SERVICE BULLETIN

NUMBER: SB 500-57-006, REV A
MODEL: ECLIPSE EA500
SUBJECT: FLAP GURNEY TAB SPEED RESTRICTION PLACARD REMOVAL

**Speed Restriction Placard Location on Throttle Quadrant
Figure 1 (Sheet 1 of 1)**

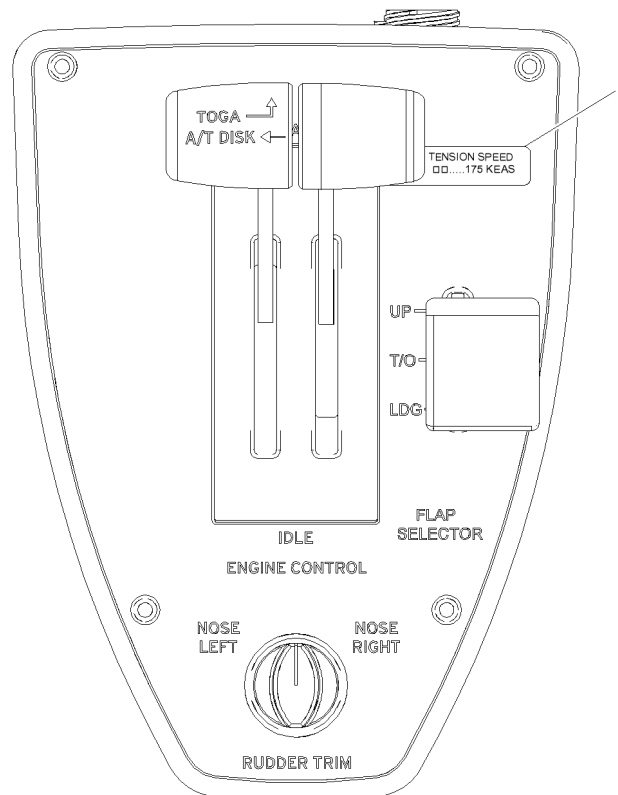
Structural analysis indicate that the maximum flap extend speed restriction imposed on aircraft with flap gurney tabs was not needed.

This Service Bulletin (SB) removes the Maximum Flap Extend Speed restriction placard for aircraft with a Gurney tab from the throttle quadrant lightplate of the aircraft.

- Carefully remove placard P/N 11-121677 from throttle quadrant lightplate (1, Figure 1). Gently clean any adhesive from lightplate with a clean, lint free cloth and isopropyl alcohol.
